An Bord Pleanála Oral Hearing

Dublin to Cork Railway Line Level Crossings

Brief of Evidence

**Cork Line Level Crossings Oral Hearing
Brief of Evidence of Gerry Healy
Summary of proposed Railway Order & Railway Works**

Figure 2.5: XC201 Thomastown Proposed Route Alignment

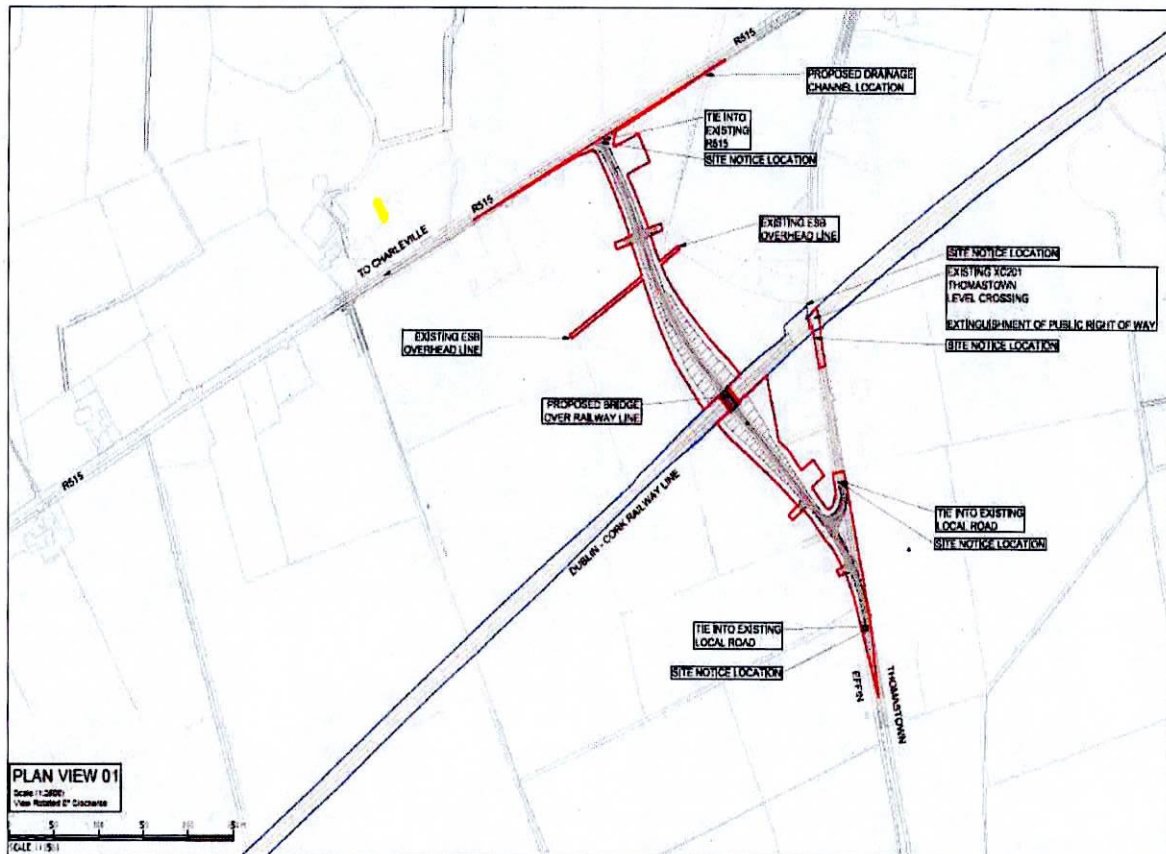
- 80 Effin GAA are delighted with the development of the new railway bridge. However, looking at the plans we see that the new development is only a single lane road. We believe that this will restrict access to our club and a double lane road is the only safe solution, and a safe new junction layout where the new road meets the R515.

- 121 There are safety concerns with the width of the road which is not wide enough to pass safely through. The new junction planned for the Charleville -Kilmallock road (R515) needs to be reviewed as it will cause stacking of vehicles when turning off the R515 to the new road.

Figure 2.11: XC212 Ballycoskery Proposed Alignment

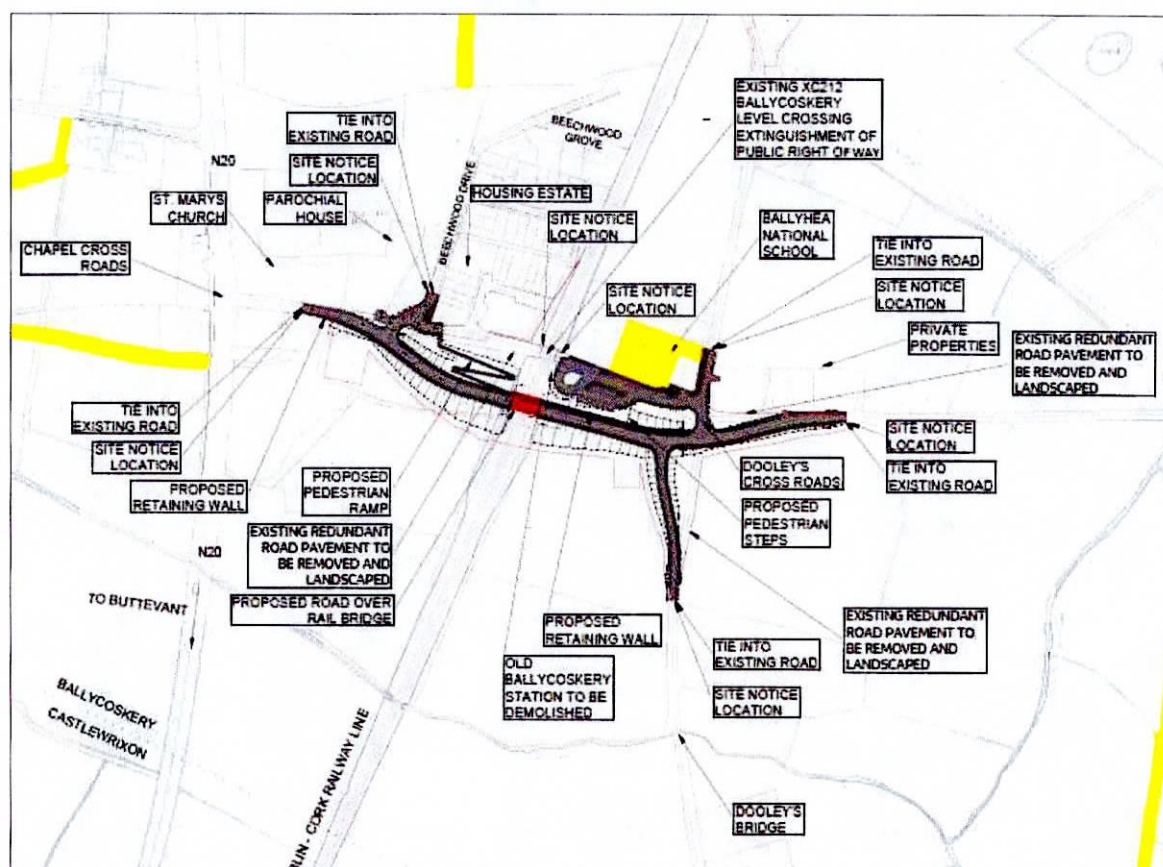
310 Planning - XC212 Ballycoskery - Drawing No. 2111000-JAC-HGN-XC212-DR-CB-0001(i) - Plan - this drawing appears to have spurious detail (possibly survey lines), that is not included on other drawings. The level of detail makes the drawing almost illegible in places.

312 Planning - XC212 Ballycoskery - Drawing No. 2111000-JAC-HGN-XC212-DR-CD-0001 (i) - Longitudinal Profile A-A - steps are missing at the pedestrian ramp.

311 Comment noted.
